ADDENDUM #1

VILLAGE OF KIMBERLY

WELHOUSE DRIVE & CURTIN AVENUE

SANITARY, WATER & STORM SEWER RECONSTRUCTION

- l. **Storm lateral connections are required as follows:**
 - 1) **4-inch PVC to storm sewer 12-inch and larger.**
- Kor 'N' Tee tap with rubber seal.
 - 2) **4-inch PVC to new 6-inch and 8-inch PVC storm sewer.**

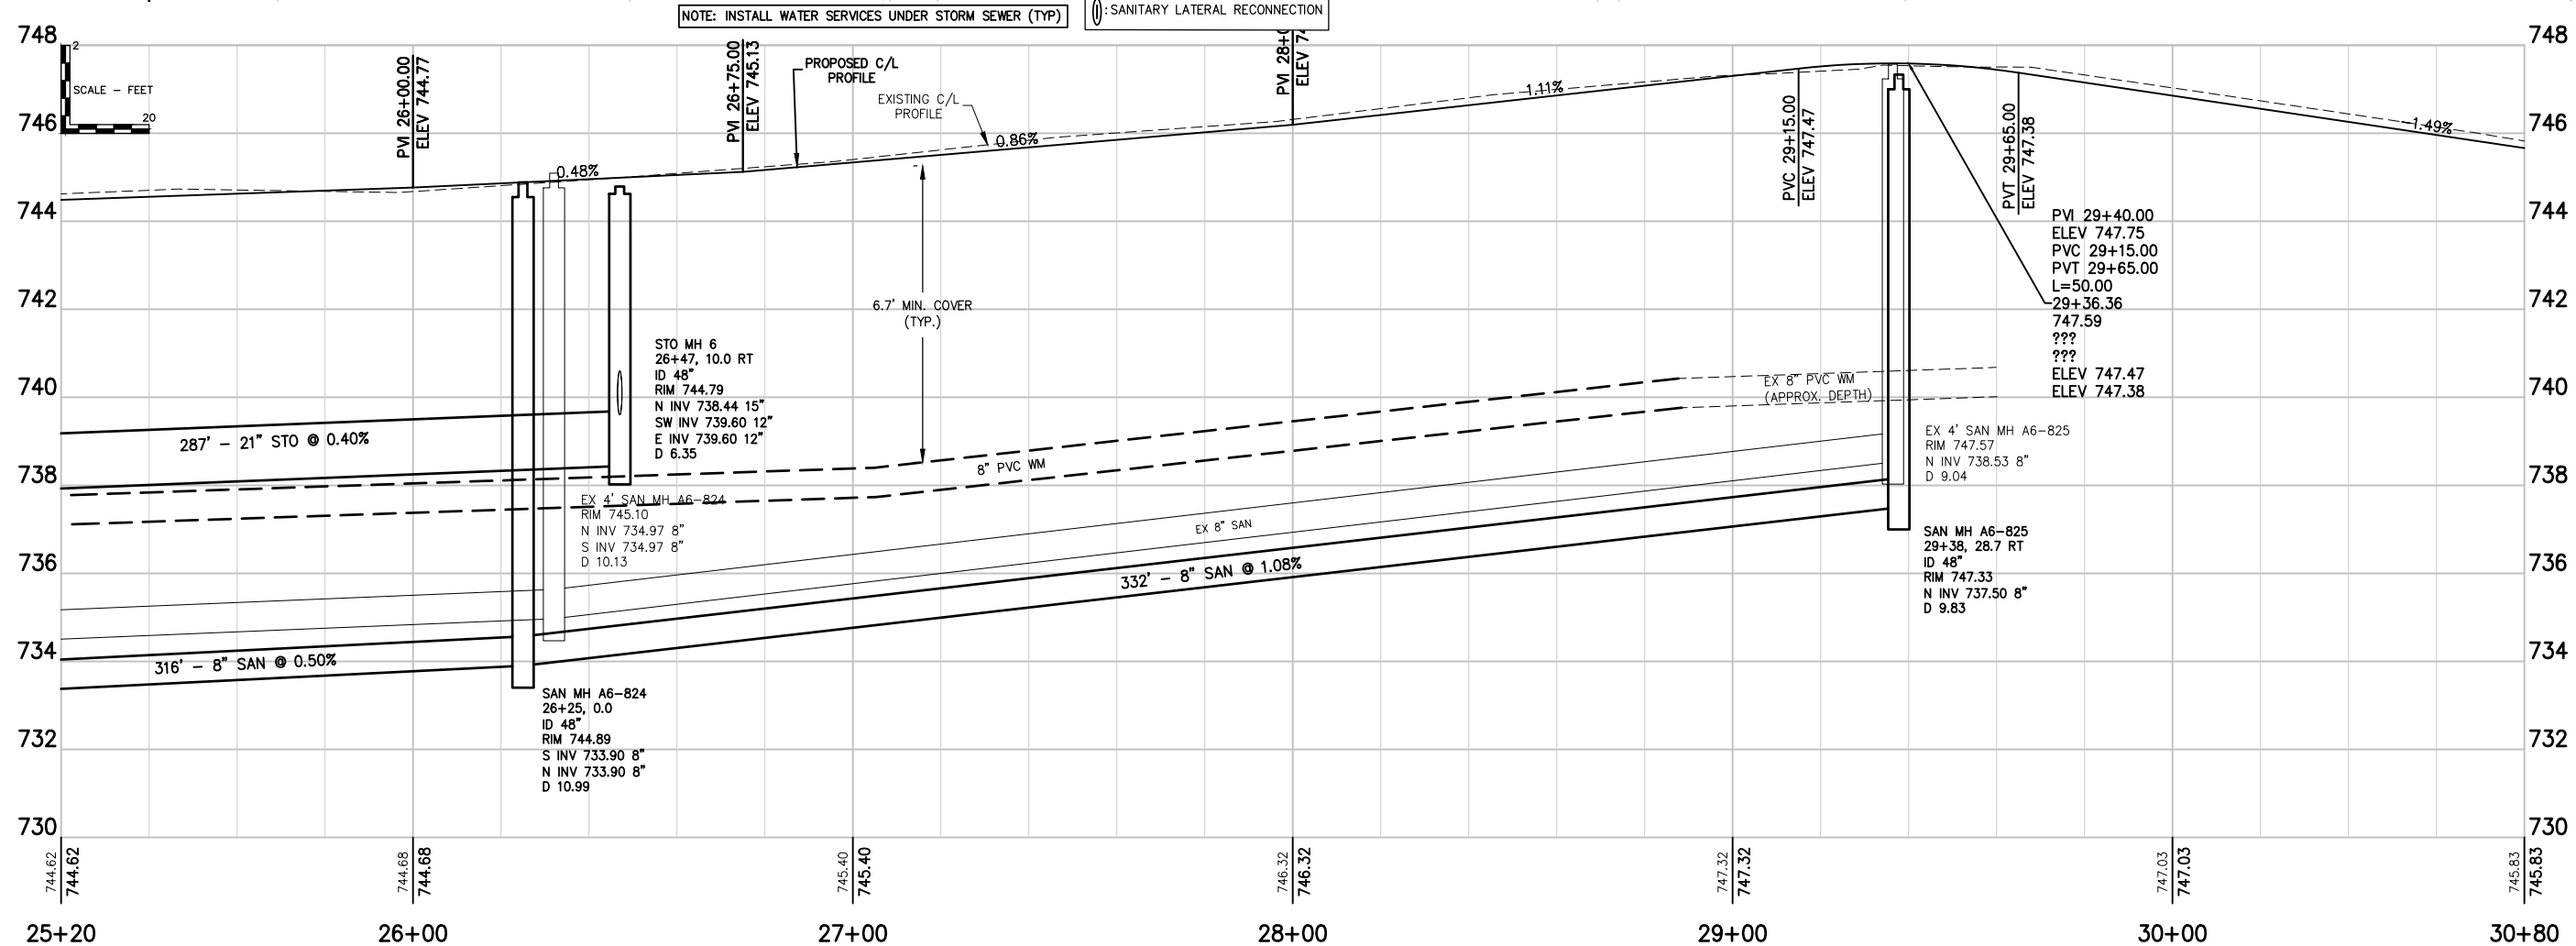
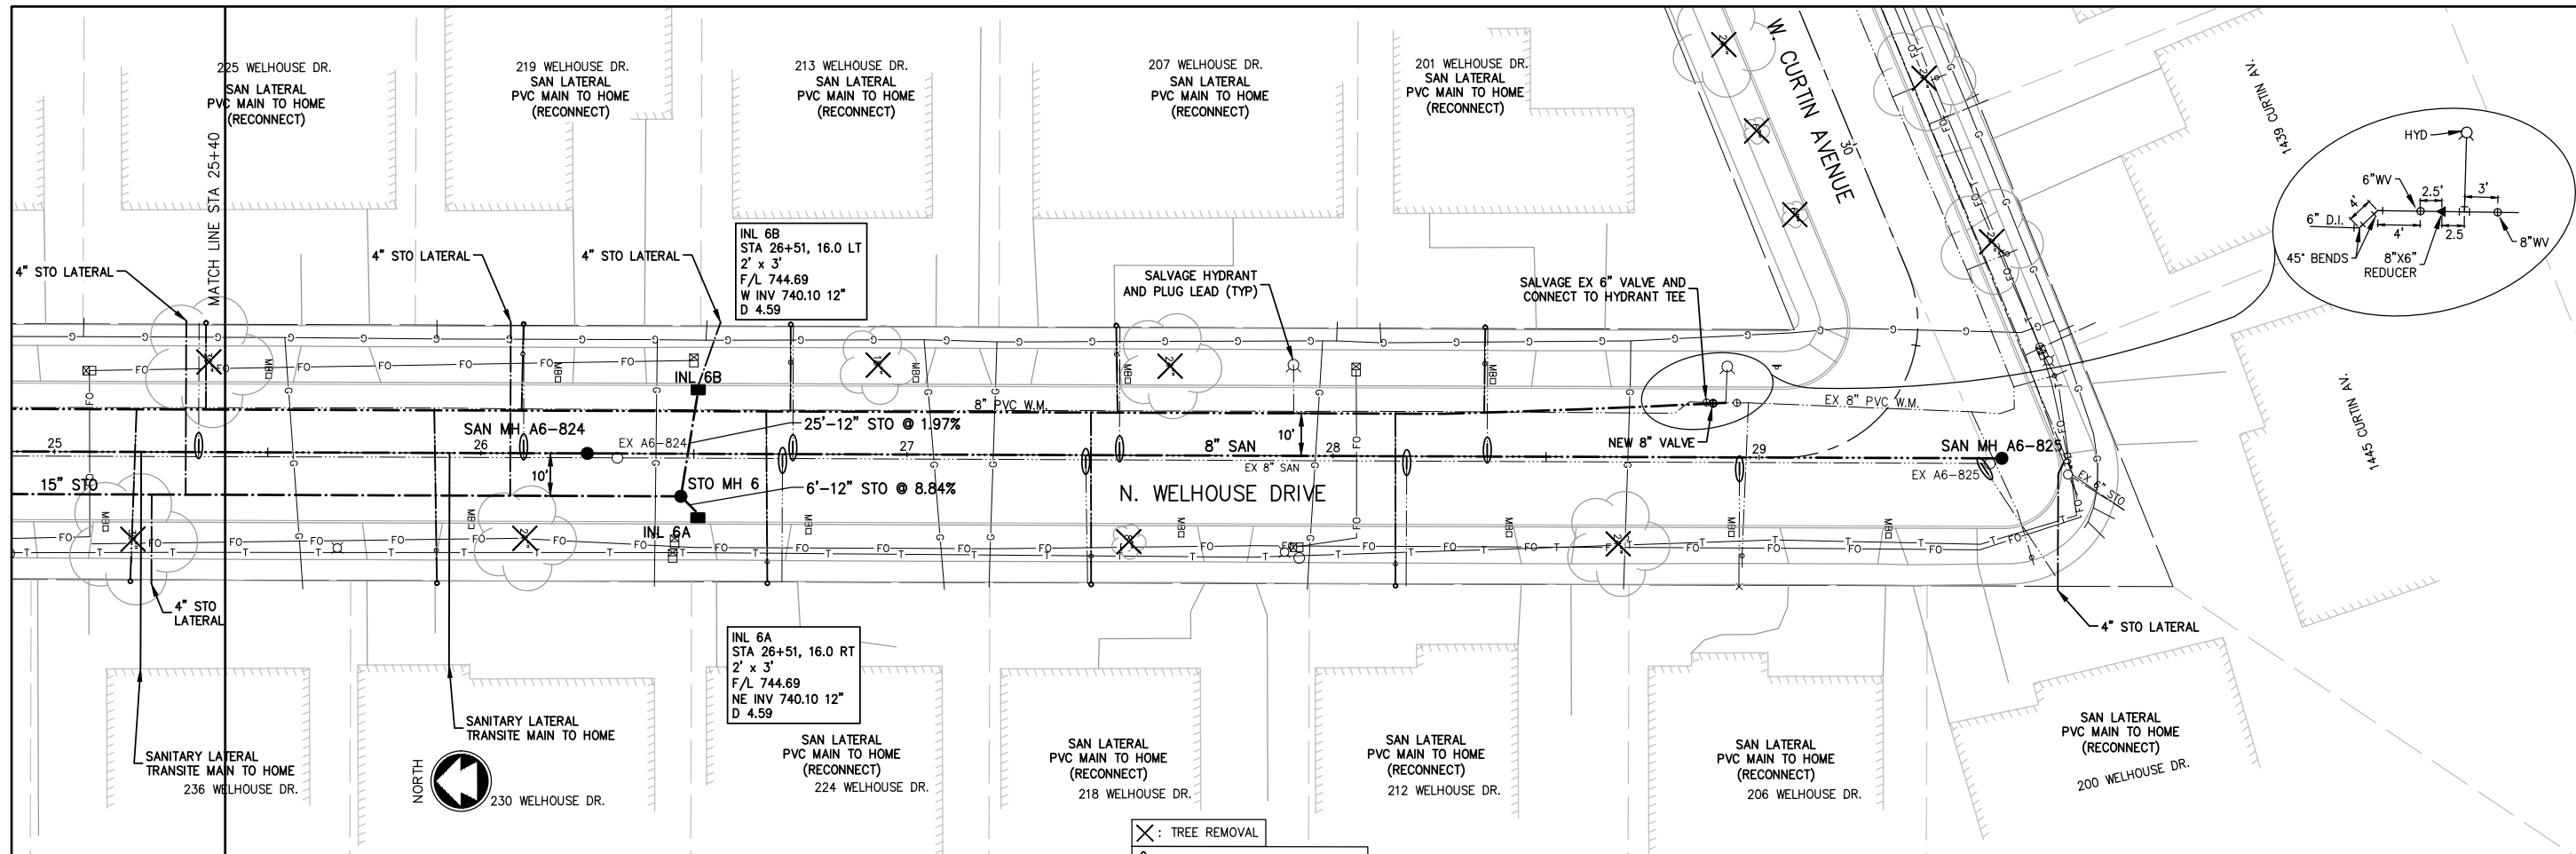
- PVC wye fittings.
